This combined synopsis/solicitation is hereby amended to answers questions received from potential offerors, provide for a site visit and extend the date for receipt of proposals.

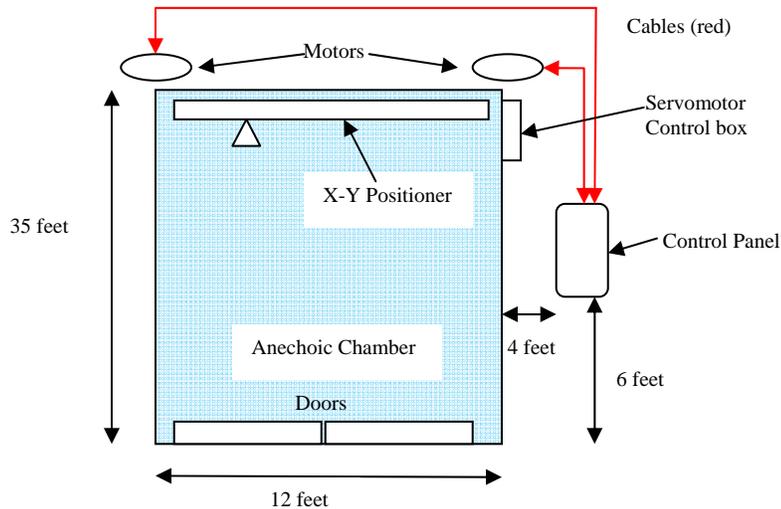
6. QUESTION: How far is the vendor provided control panel from the chamber?

ANSWER: The current control panel is a rack-mounted assembly located outside of the chamber to the right of the chamber (looking from the chamber door towards the X-Y Positioner). The figure below shows the location of the rack. It is desired that the panel be no further than it currently exists. Site visit is encouraged.
